**RUBIDOUX COMMUNITY SERVICES DISTRICT
CONTRACT DOCUMENTS AND SPECIFICATIONS
FOR
MARKET STREET AND 24TH STREET PIPELINE RELOCATION**

ADDENDUM NO. 1

MARKET STREET AND 24TH STREET PIPELINE RELOCATION

| SCALE 1"=40' | <p>RUBIDOUX COMMUNITY SERVICES DISTRICT</p> <p>MARKET STREET AND 24TH STREET PIPELINE RELOCATION</p> <p>PLAN AND PROFILE STA.10+05.0± TO STA.12+06.0±</p> | <p>3</p> <p>OF 3 SHEETS</p> <p>R.C.S.D. PLAN NO.</p> |

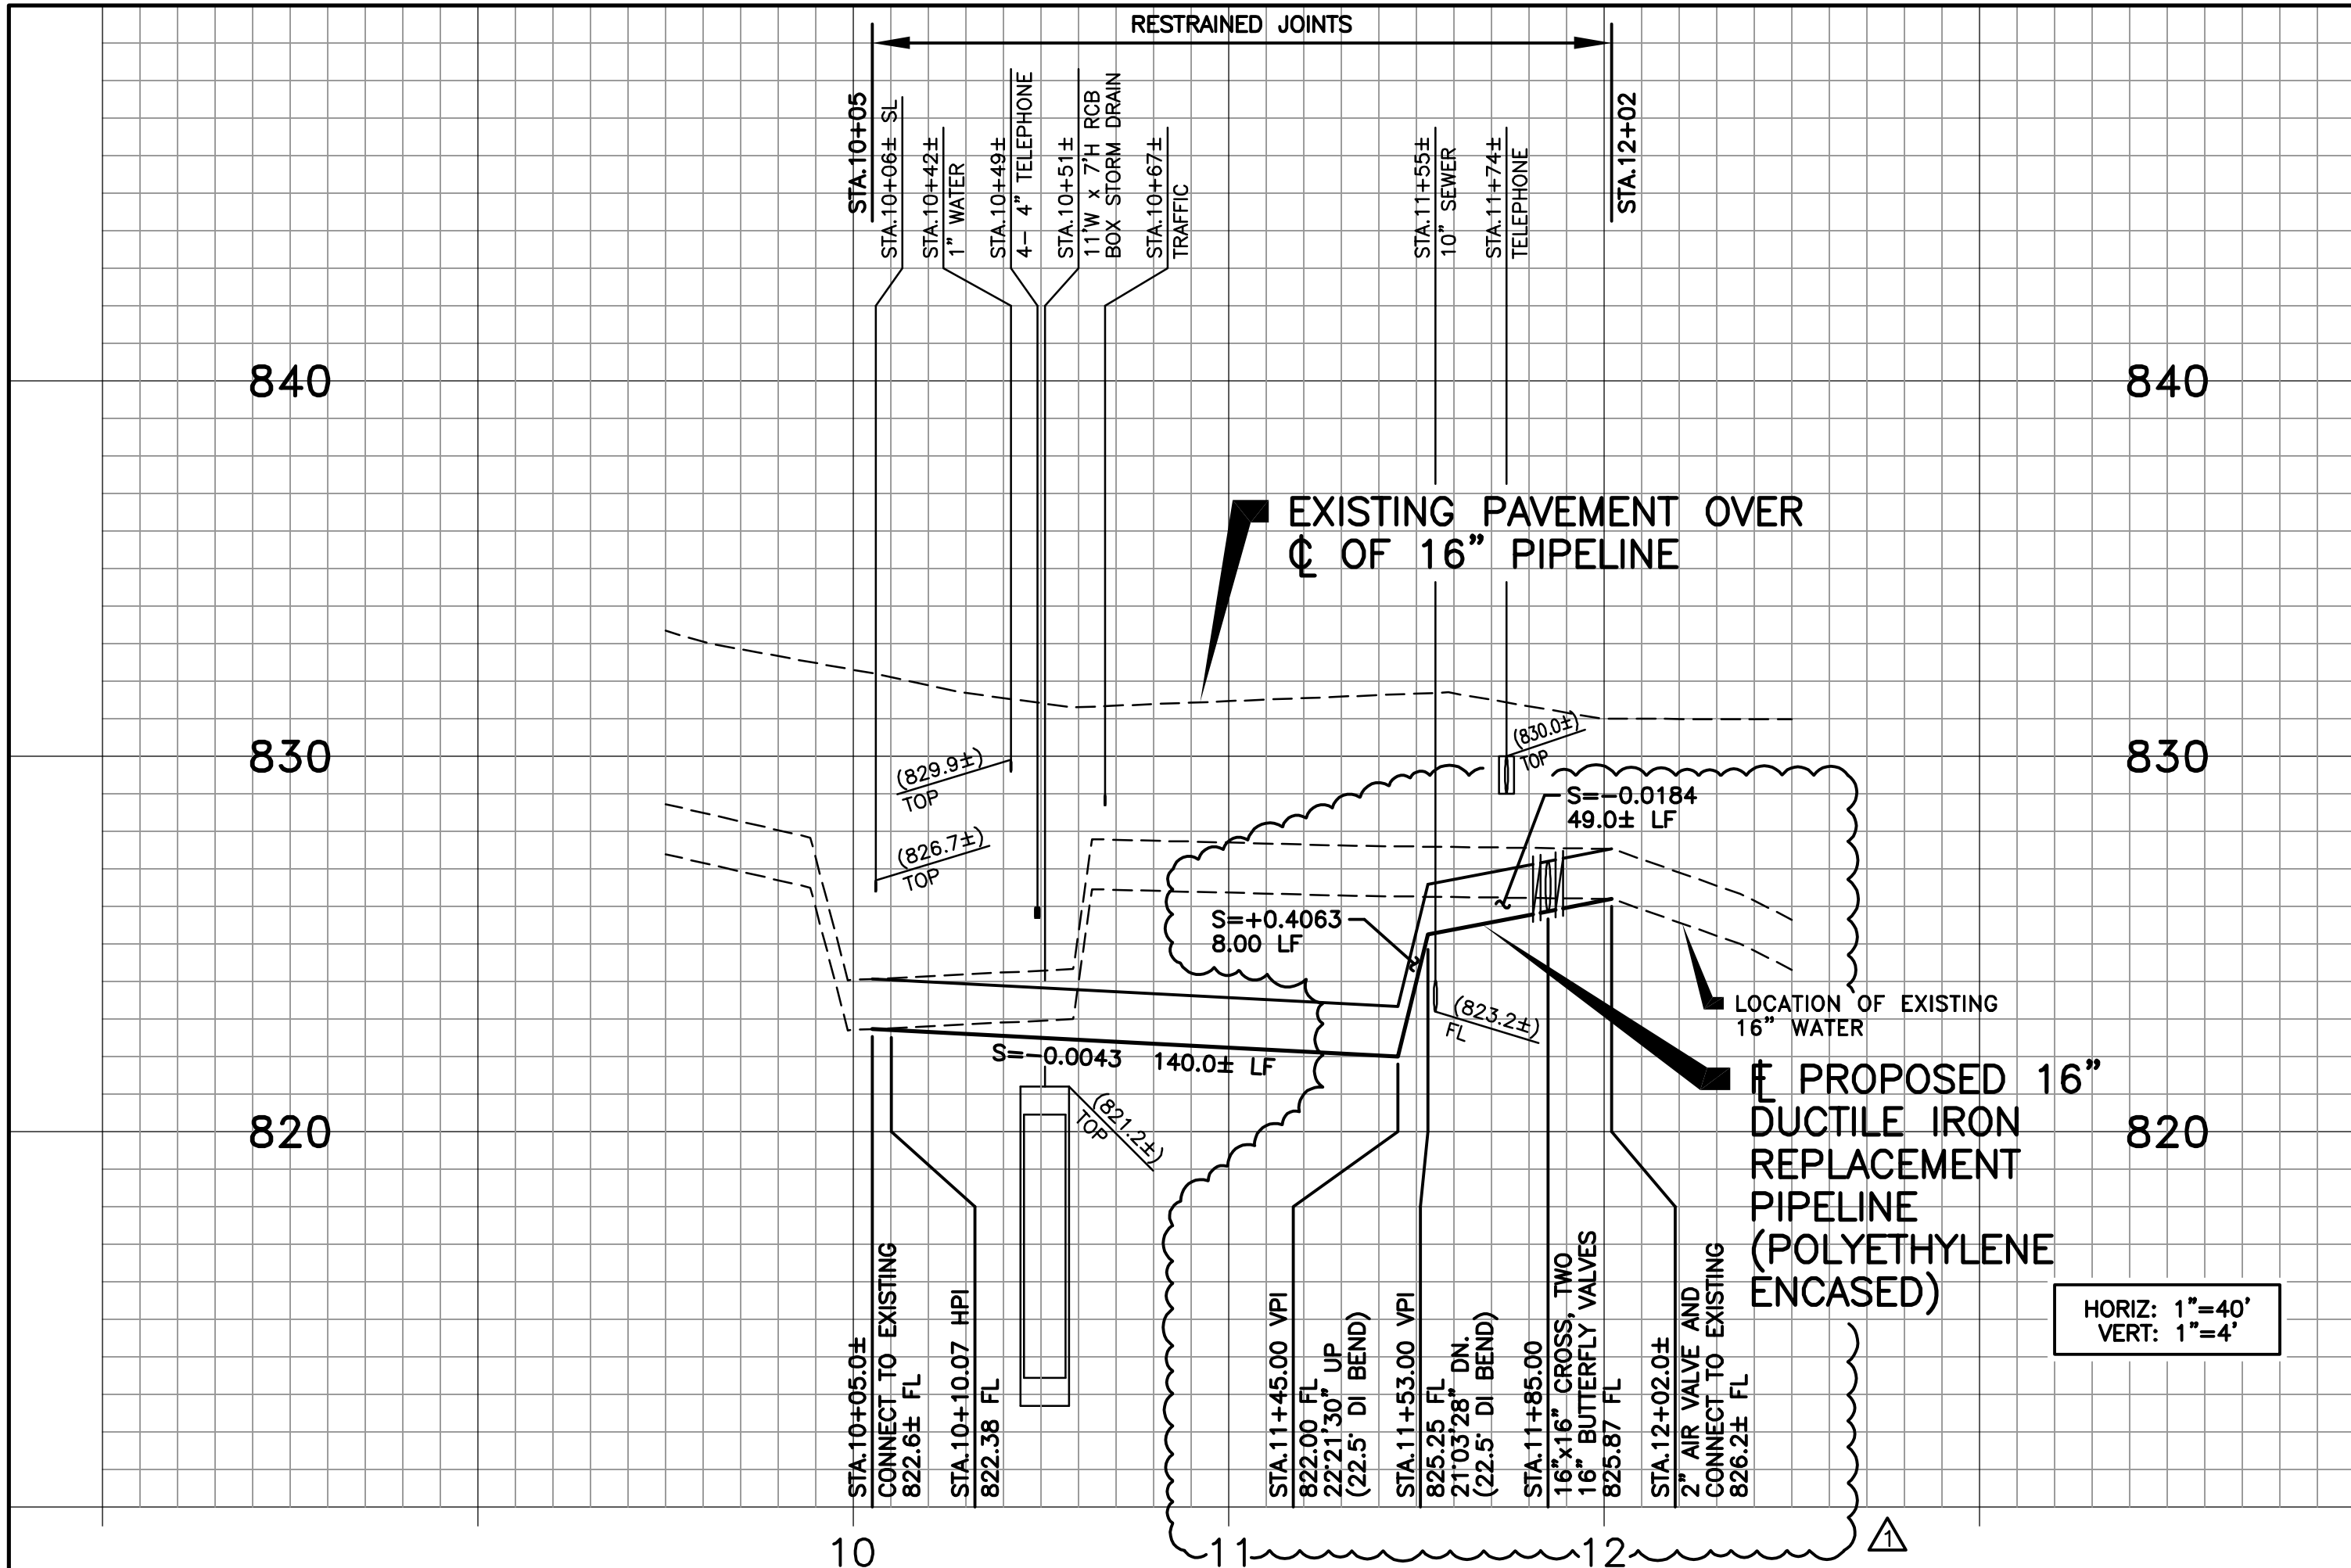
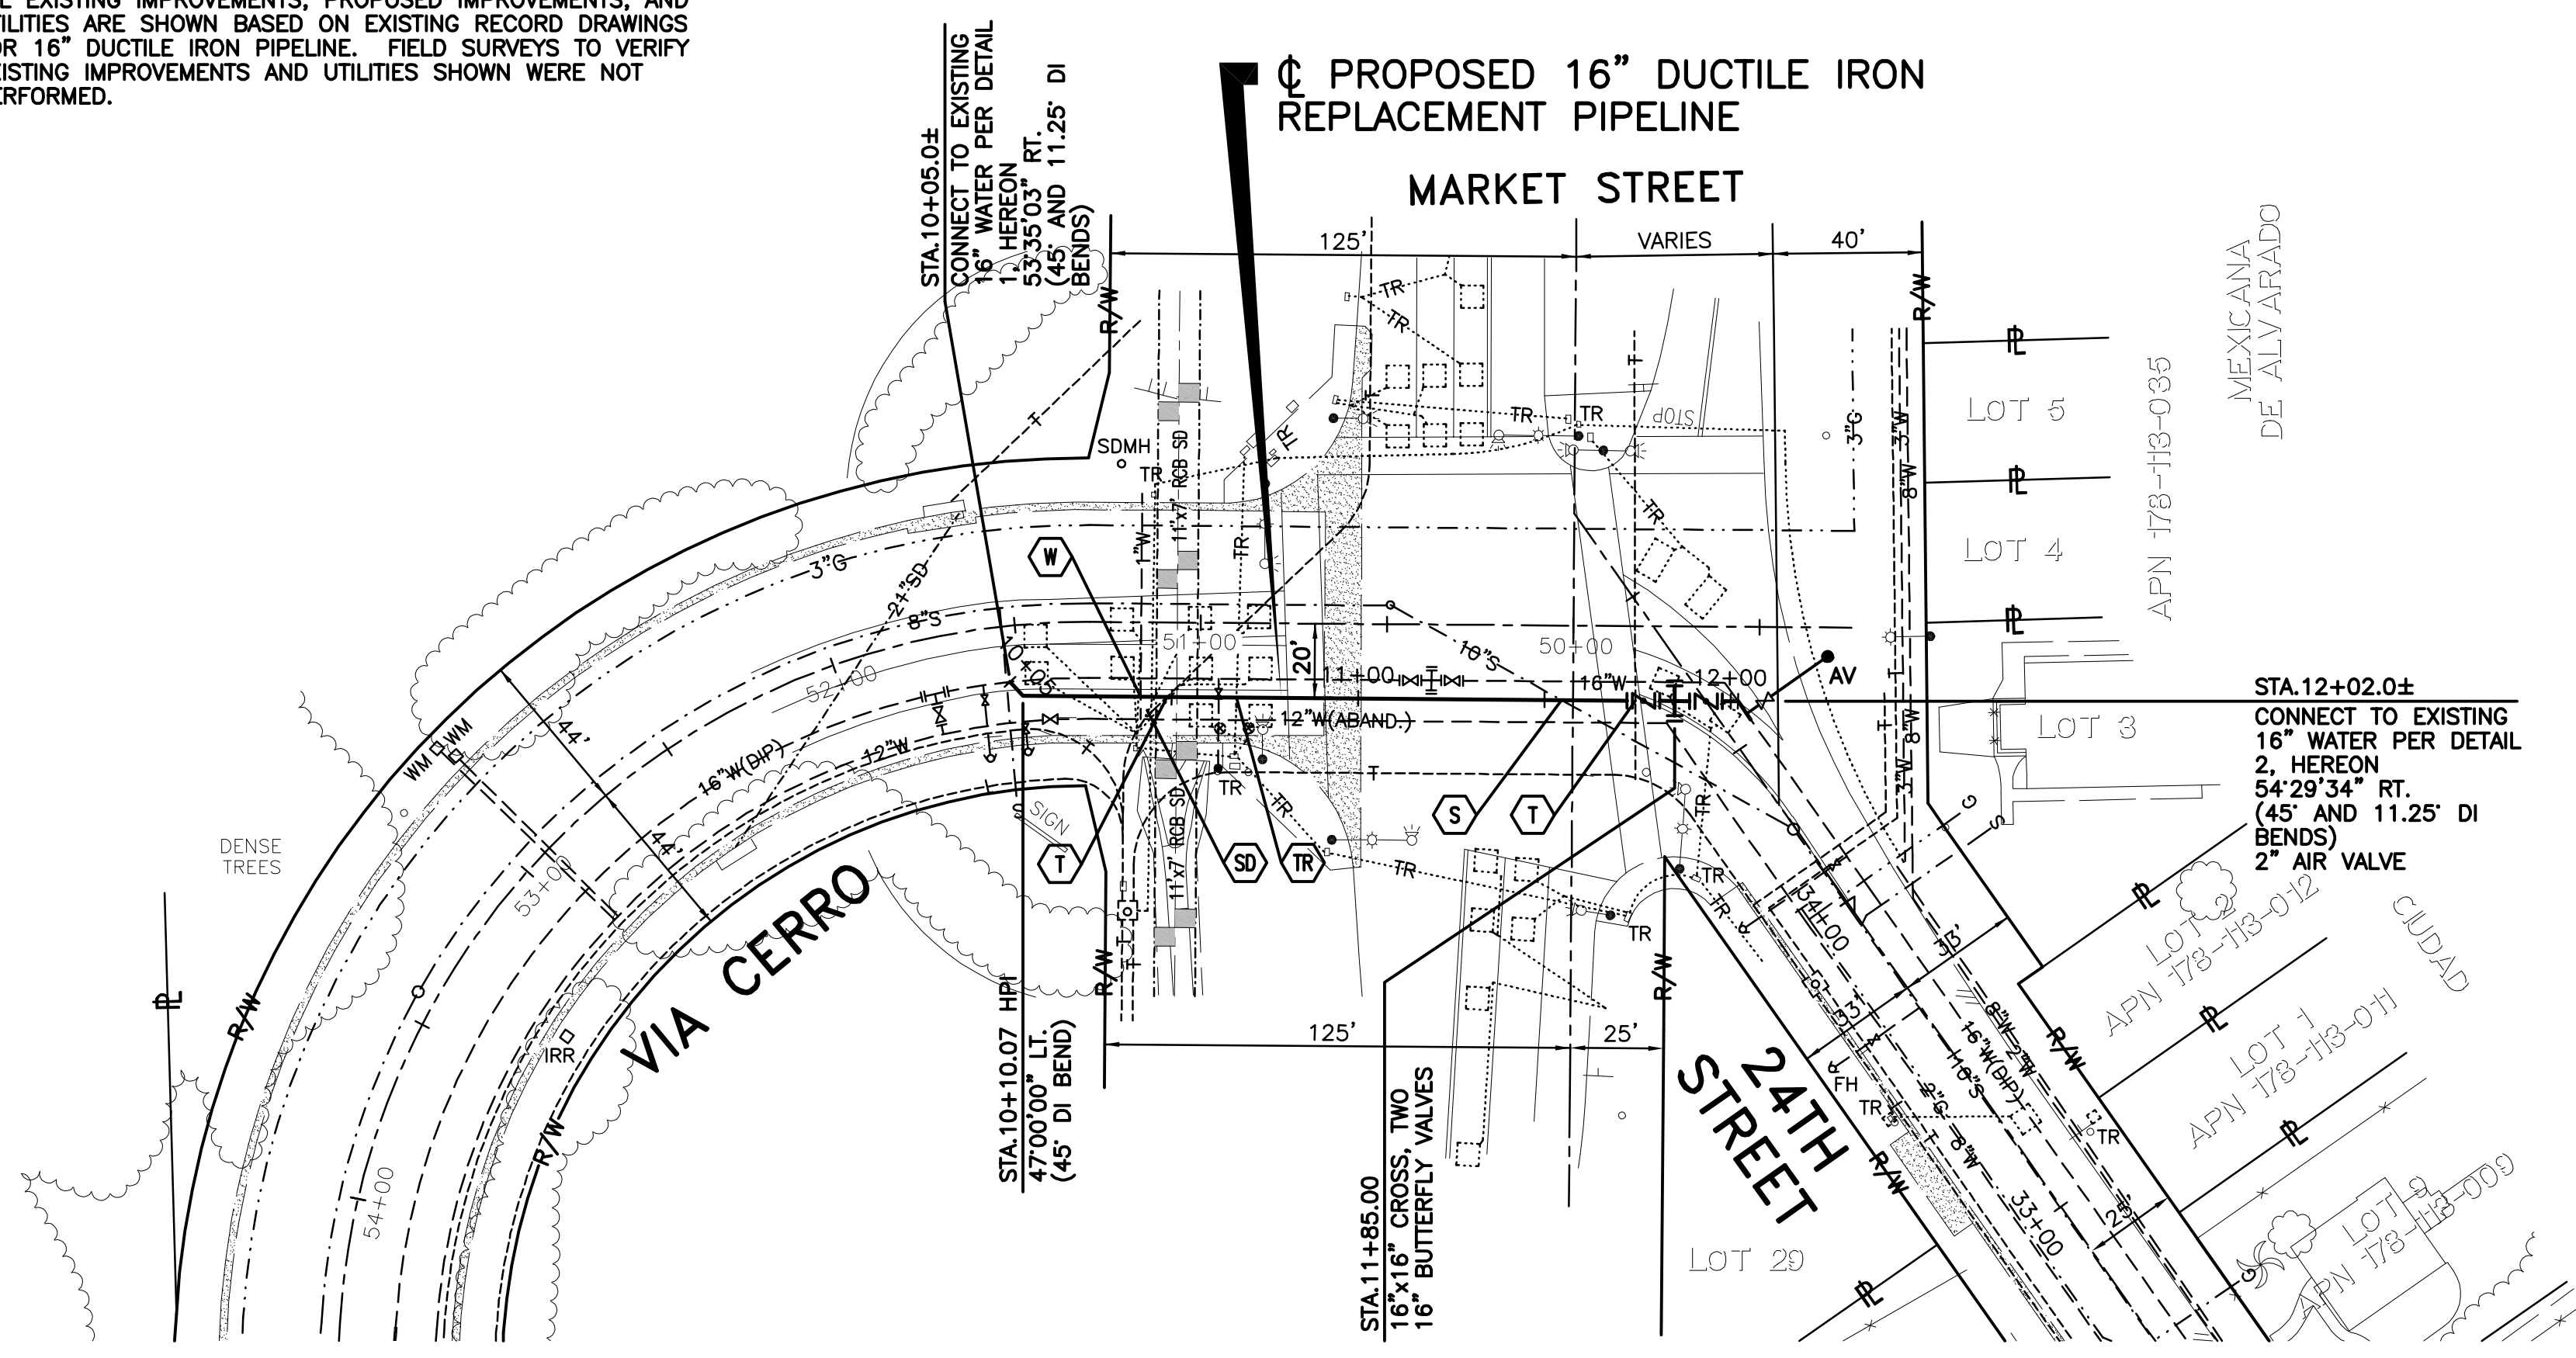
| Δ | REVISED PROFILE | 03/23/23 | SS |
